Memo

Re: Wells Fargo Bank Config

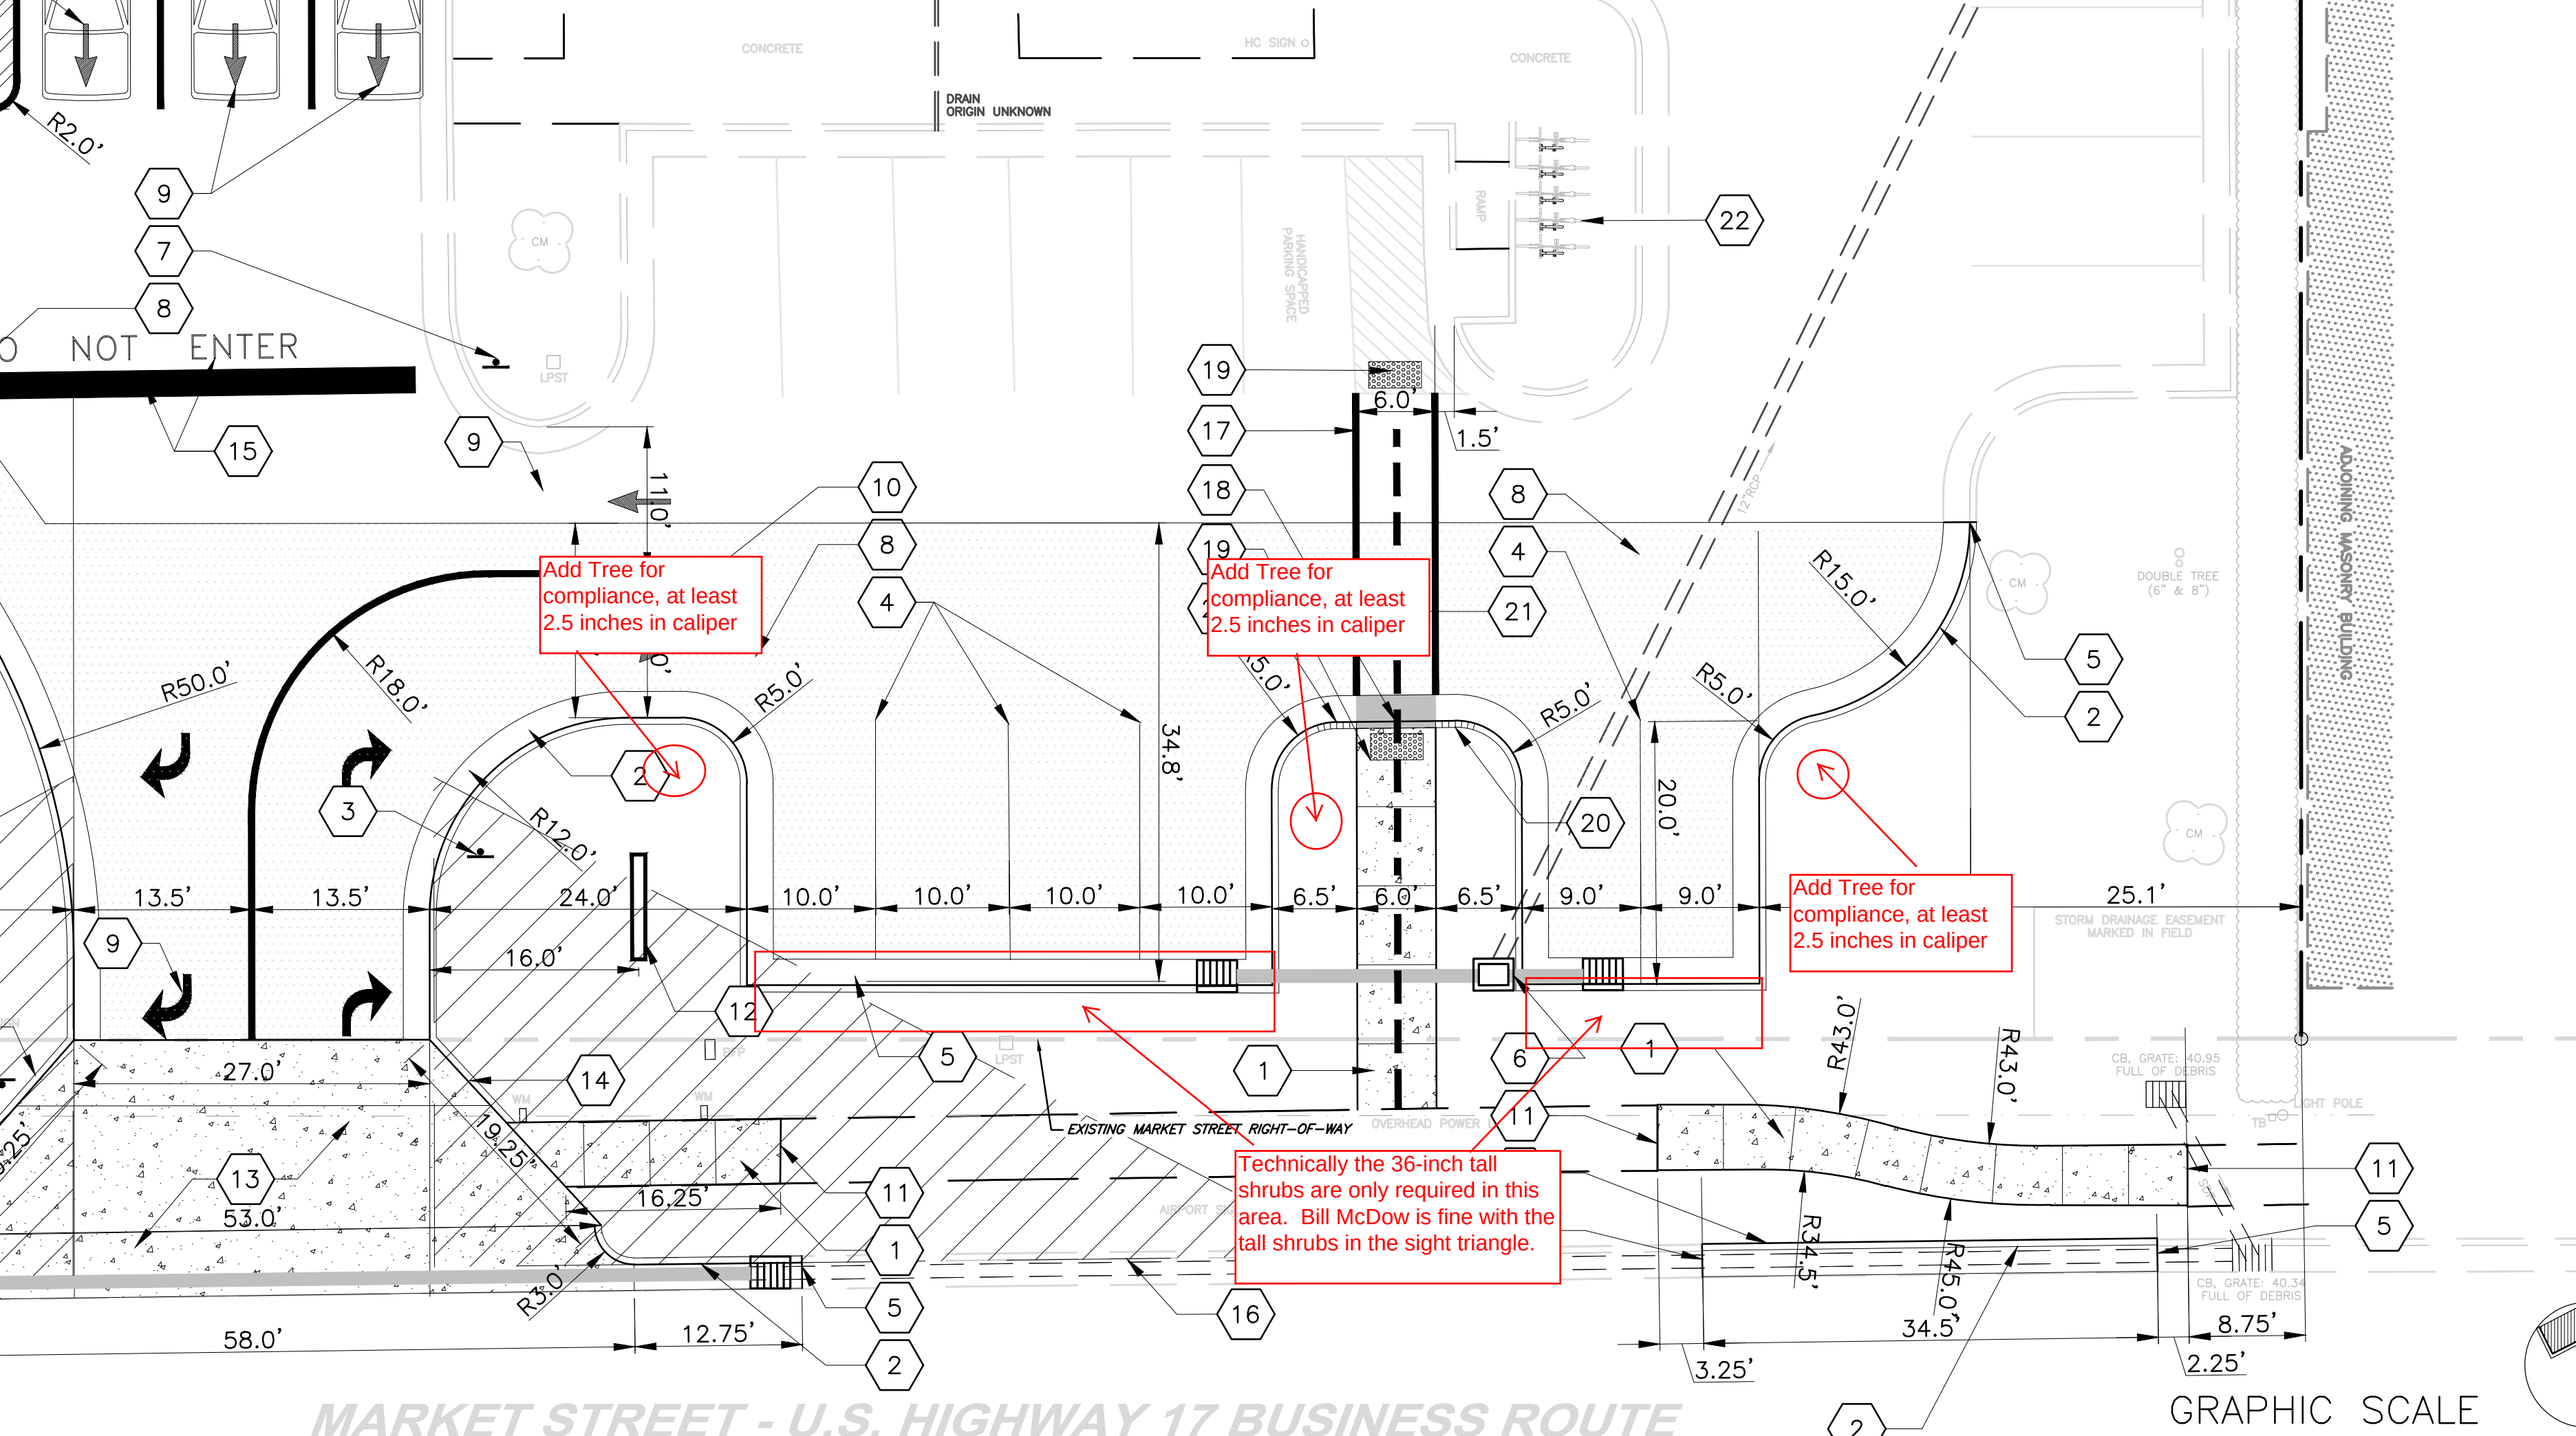
- Each landscape islands must contain one tree of at least 2.5 inches in caliper.
- The front shrub along Market Street must be at least 3 feet tall at planting. The purpose is used as a blocker of headlights onto the public street.
- See attached redline.

Add Tree for compliance, at least 2.5 inches in caliper
Add Tree for compliance, at least 2.5 inches in caliper
Add Tree for compliance, at least 2.5 inches in caliper
Technically the 36-inch tall shrubs are only required in this area. Bill McDow is fine with the tall shrubs in the sight triangle.
EXISTING MARKET STREET RIGHT-OF-WAY
MARKET STREET - U.S. HIGHWAY 17 BUSINESS ROUTE
GRAPHIC SCALE
NOT ENTER
DRAIN ORIGIN UNKNOWN
CONCRETE
HC SIGN
HANDICAPPED PARKING SPACE
RAMP
ADJOINING MASONRY BUILDING
DOUBLE TREE (6" & 8")
STORM DRAINAGE EASEMENT MARKED IN FIELD
CB, GRATE: 40.95 FULL OF DEBRIS
CB, GRATE: 40.34 FULL OF DEBRIS
OVERHEAD POWER
LIGHT POLE
R50.0'
R18.0'
R12.0'
R5.0'
R15.0'
R43.0'
R34.5'
R45.0'
R3.0'
110'
34.8'
20.0'
13.5'
13.5'
24.0'
16.0'
10.0'
10.0'
10.0'
10.0'
6.5'
6.0'
6.5'
9.0'
9.0'
25.1'
27.0'
53.0'
19.25'
16.25'
58.0'
12.75'
6.0'
1.5'
34.5'
3.25'
8.75'
2.25'
